# UNITED STATES PATENT AND TRADEMARK OFFICE

APPLICATION NO.	FILING DATE	FIRST NAMED INVENTOR	ATTORNEY DOCKET NO.	CONFIRMATION NO.
10/523,896	11/02/2005	Arthur Raymond Winn	BMADD 1031736	9489
27111 GORDON & REES LLP 101 WEST BROADWAY SUITE 1600 SAN DIEGO, CA 92101	7590 06/11/2009		EXAMINER VOLZ, ELIZABETH J	
			ART UNIT 3781	PAPER NUMBER
			NOTIFICATION DATE 06/11/2009	DELIVERY MODE ELECTRONIC

### Office Action Summary

## **DETAILED ACTION**

**Figure 1 (Brown)**

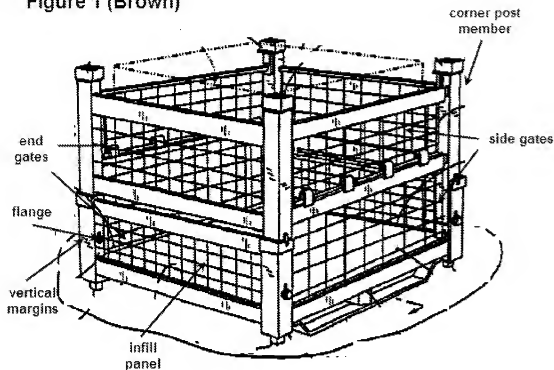
11. Claims 8, 9, 11 and 13 are rejected under 35 U.S.C. 102(e) as being anticipated by Brown (U.S. Patent No. 6,691,885).
12. Regarding Claim 8, Brown discloses a collapsible storage container 10 (Figure 1) comprising a base 12 (Figure 1); two pairs of opposite side gates (Figure 1 below) and

two pairs of opposite end gates (Figure 1 below), each said gate pivotally mounted with respect to the base for folding movement between an erect in-use position (Figure 1) and a collapsed position (Figure 4) on top of the base, each said gate having an infill panel 122 (Figure 5) having an inner face and an outer face (Figure 5), and an outer perimeter frame secured to the outer face of the infill panel so as to define at least vertical margins (Figure 1 below) thereof; said adjacent vertical margins of adjacent said gates when in their erect in-use positions, being interconnected by a corner post member (Figure 1 below) detachably secured to and abutting each said vertical margin, each said corner post member having a pair of inwardly directed locking flanges (Figure 7) which respectively locate in outwardly opening flange receiving slots (Figure 4) on the vertical margins of adjacent gates when the gates are in their erect in-use positions, the corner post members extending along the vertical margins of the gates there being locking means 68 (Figure 18) for releasably locking each within its associated said flange receiving slot.

13. Regarding Claim 9, Brown discloses each of the gates has a two-flanged elongate angle frame member extending along each of its vertical margins with a first flange (Figure 1 above) abutting the inner face of the infill panel and a second outwardly directed flange 68 (Figure 18) extending parallel to the vertical margin of the gate and spaced outwards therefrom so as to define said outwardly opening flange receiving slot 48 (Figure 11) extending along the entire length of the vertical edge of the gate.
